ADDENDUM No. 2

PROJECT: University Medical Center Physicians DATE: 03/03/2025
New Wolforth Clinic PROJECT NO.: 22415
Project Location

SHEET NO.
E-03
4 OF 8

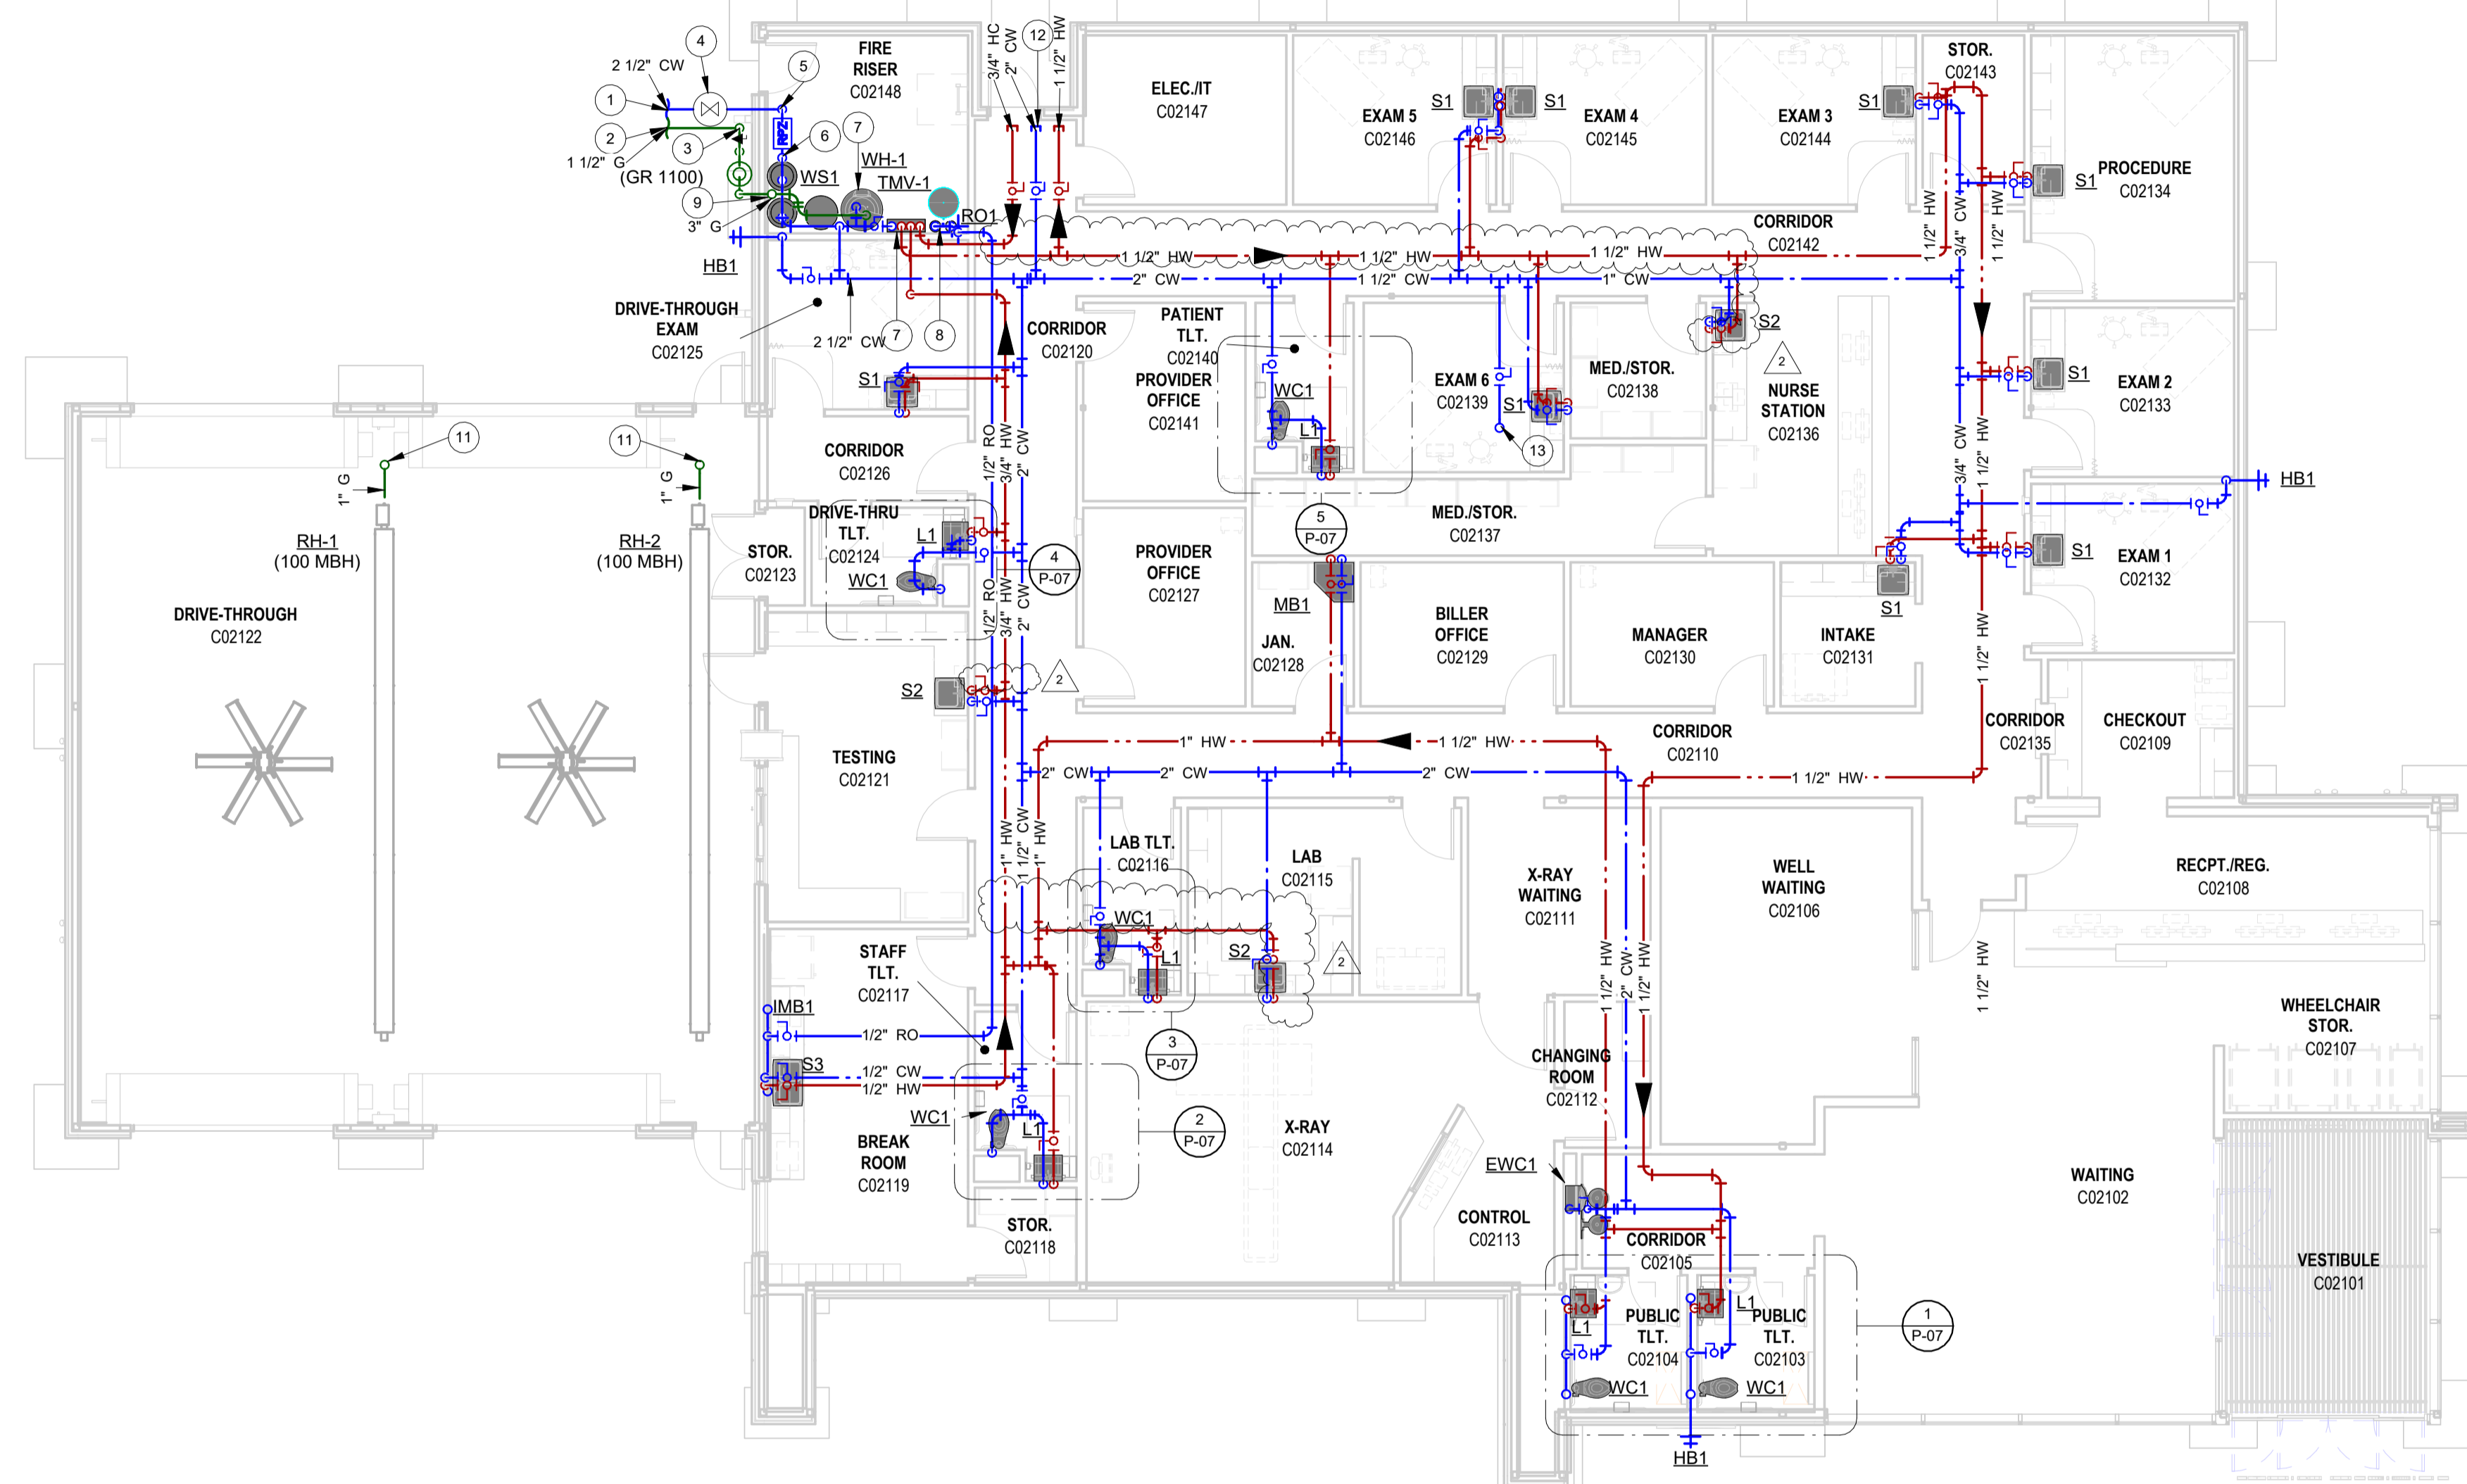
ITEM #2: Additional conduits – On sheet E-03, at the south end of Nurse Station C02136, add two additional conduits down the wall and into the kick wall of the millwork, noted with Keyed Note 22.

ITEM #7: Electrical Items – Refer to the items listed below and the attached, revised power Plan E-03.

1. Lightning protection shall not be required for this project.
2. Fire alarm circuits may be Class B.
3. Underground communication service does not require concrete encasement.
4. Communication pullbox shall be similar to Vaughn #5 pullbox.
5. Data and telephone cabling shall be yellow.
6. Provide power at door 120A to serve electrified door strike.

22. PROVIDE (2) - 3/4" SPARE CONDUITS FOR FUTURE CONNECTION IN MILLWORK. EXTEND THROUGH ADJACENT WALL AND TO AN ACCESSIBLE POINT ABOVE CEILING.
23. PROVIDE RECEPTACLE AND 3/4" CONDUIT TO SERVE IRRIGATION CONTROLLER. COORDINATE EXACT LOCATION WITH IRRIGATION CONTRACTOR.

SHEET NO.
P-02

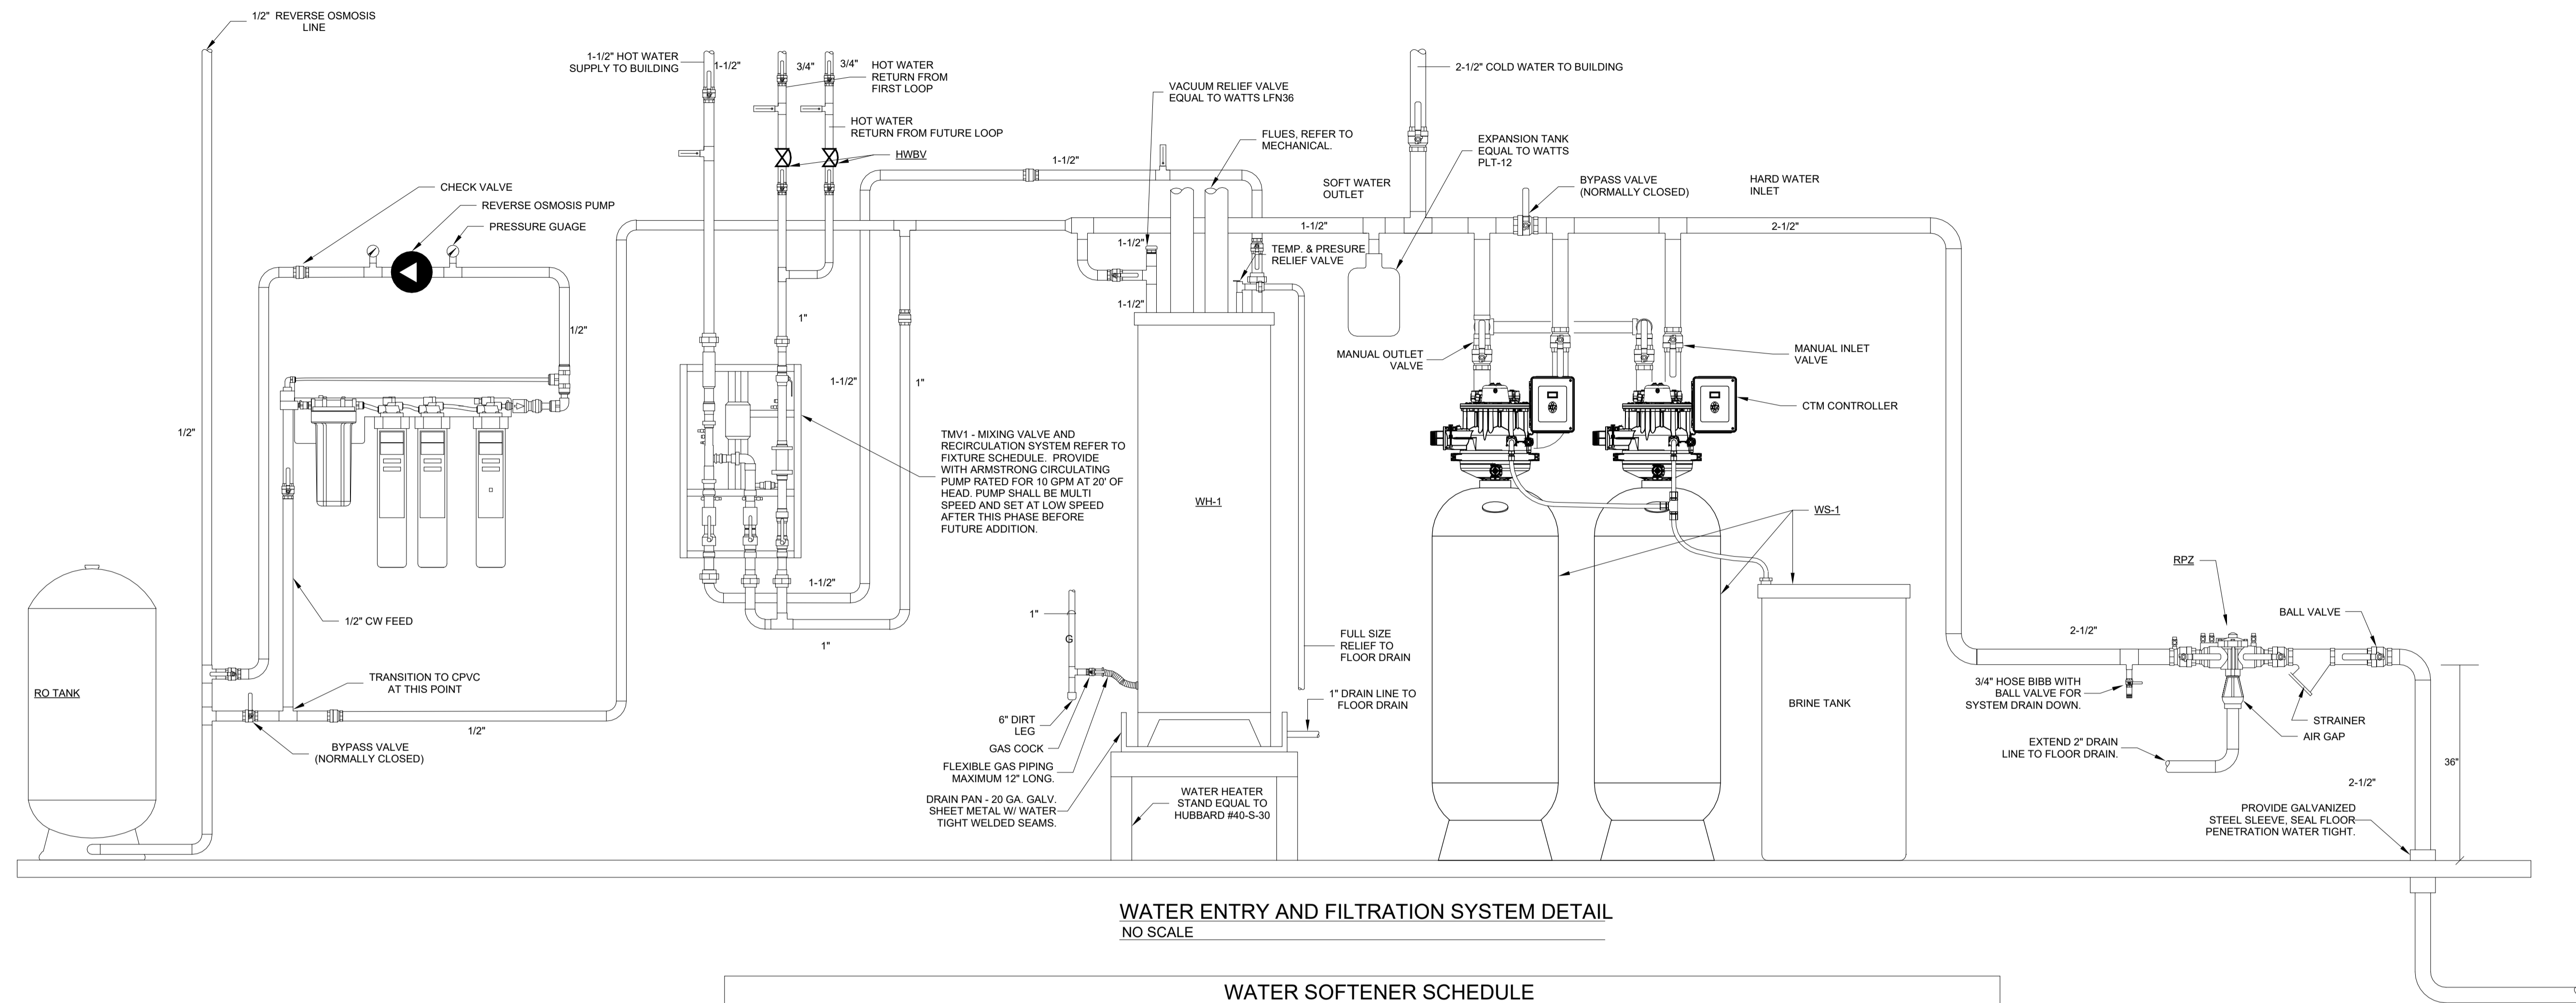
ITEM #8: Plumbing Sheets – Refer to the attached, revised Plumbing Sheets, P-02, P-04, and P-08 for revisions to RO system.

- TURN 1/2" CW LINE DOWN TO SERVE RO SYSTEM. PROVIDE BALL VALVES IN INLET AND OUTLET AND FULL BYPASS WITH NORMALLY CLOSED BYPASS VALVE. REFER TO DETAIL. EXTEND RO WATER LINES TO ALL DRINKING EQUIPMENT AS SHOWN.
